**FIFTH FIVE-YEAR REVIEW REPORT FOR THE  
ALABAMA ARMY AMMUNITION PLANT – AREA B  
SUPERFUND SITE  
TALLADEGA COUNTY, ALABAMA**

**FINAL**

August 2023

Figure no.	Project No.	File Name	Date
<b>1-3</b>	310174.00.01.01. 014.00145	Figure 1-3 Parcels 8x11	3/8/2023

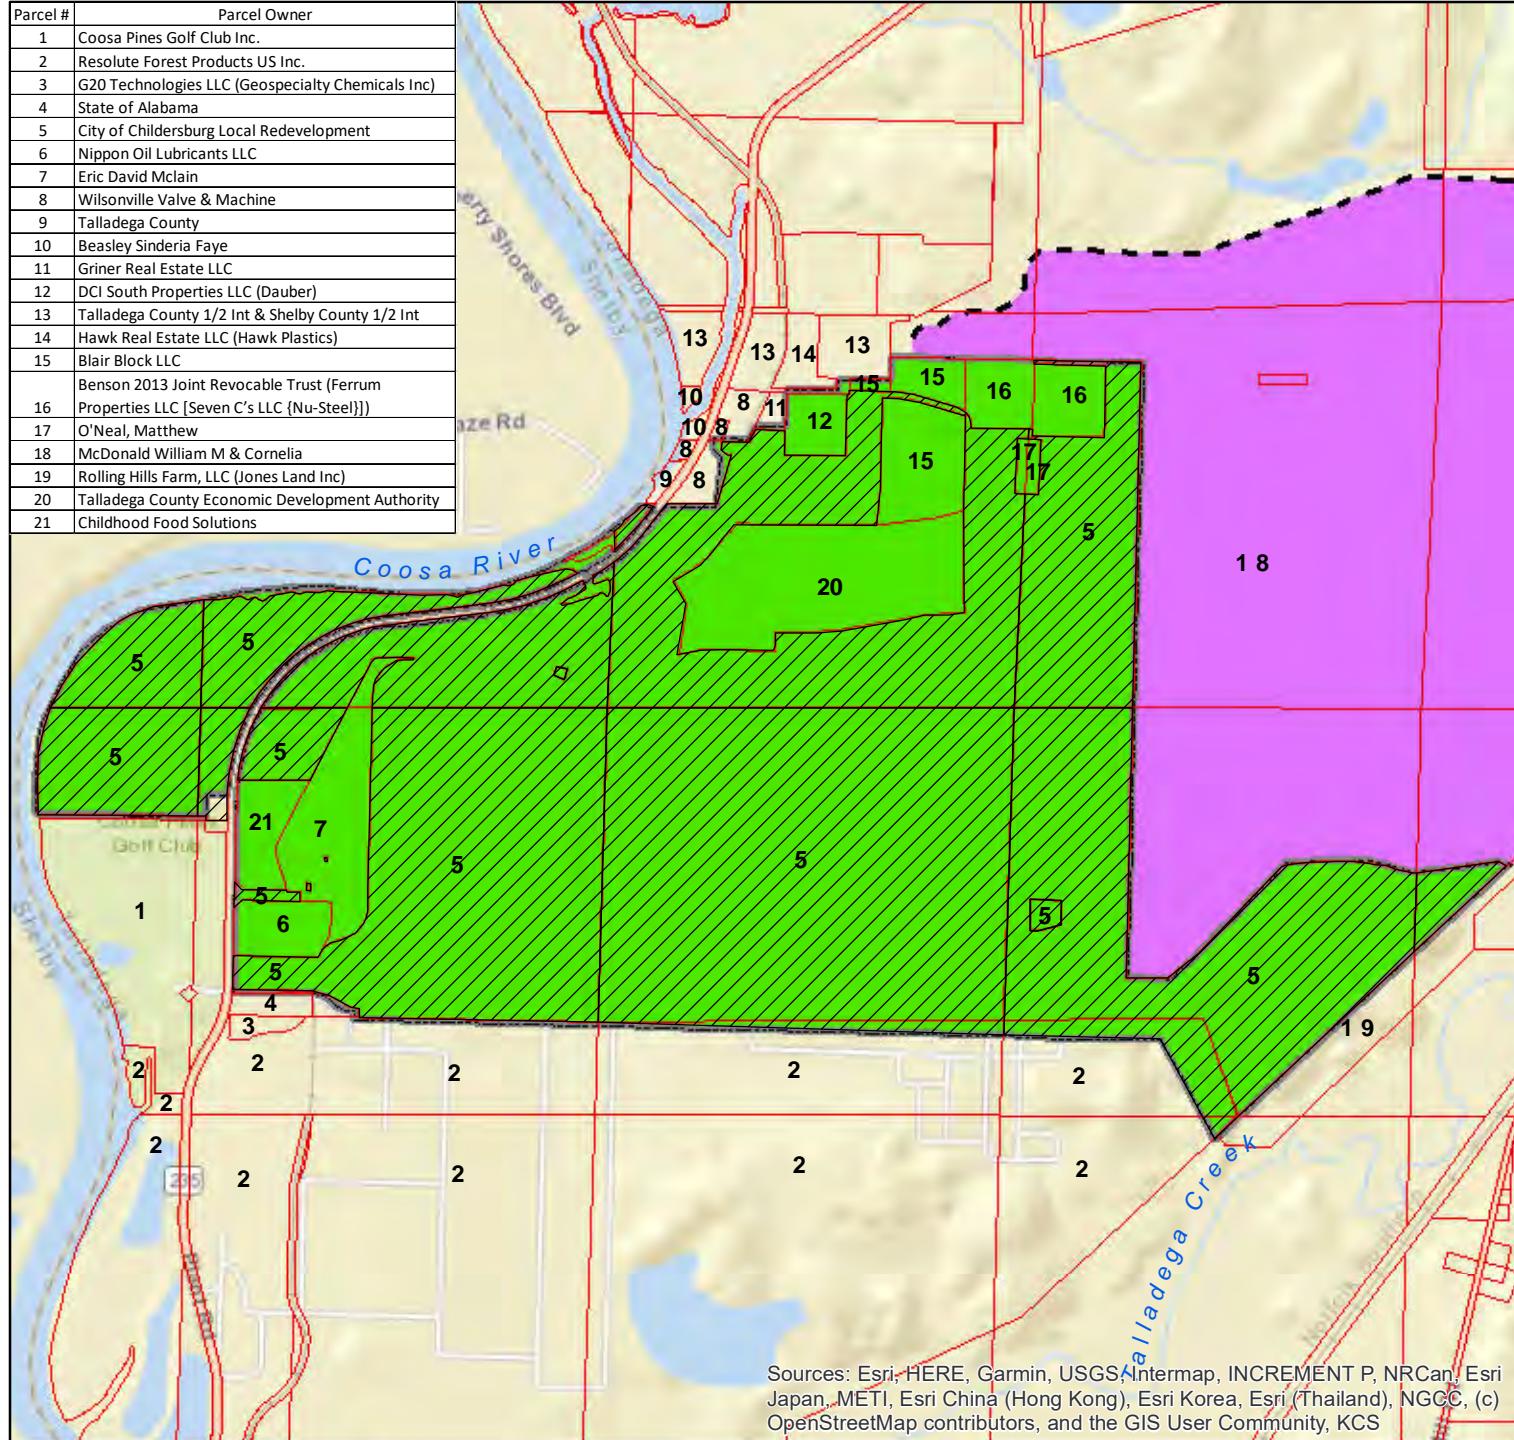
10. Figure 1-3, ALAAP Area B and Adjacent Parcel Owners, Industrial Land Use, Page 1-9: According to Figure 1-3, Parcel 2, which is located within Area B, is owned by Resolute Forest Products US Inc.; however, Section 1.1 [Site Background] does not discuss that a portion of Parcel 2 is located within Area B. Please include text in Section 1.1 that discusses a portion of Parcel 2 is located within Area B and if there are any study areas located within the portion of Parcel 2 that is located within Area B.

10.	Figure 1-3, ALAAP Area B and Adjacent Parcel Owners, Industrial Land Use, Page 1-9: According to Figure 1-3, Parcel 2, which is located within Area B, is owned by Resolute Forest Products US Inc.; however, Section 1.1 [Site Background] does not discuss that a portion of Parcel 2 is located within Area B. Please include text in Section 1.1 that discusses a portion of Parcel 2 is located within Area B and if there are any study areas located within the portion of Parcel 2 that is located within Area B.	Clarification. The figure has been revised to depict parcel ownership more accurately in the southeastern portion of ALAAP – Area B. It is believed that the Talladega County parcel ownership incorrectly shows the location of the boundary. The boundary shown on the revised figure is that generated through surveying of the ALAAP – Area B boundary.
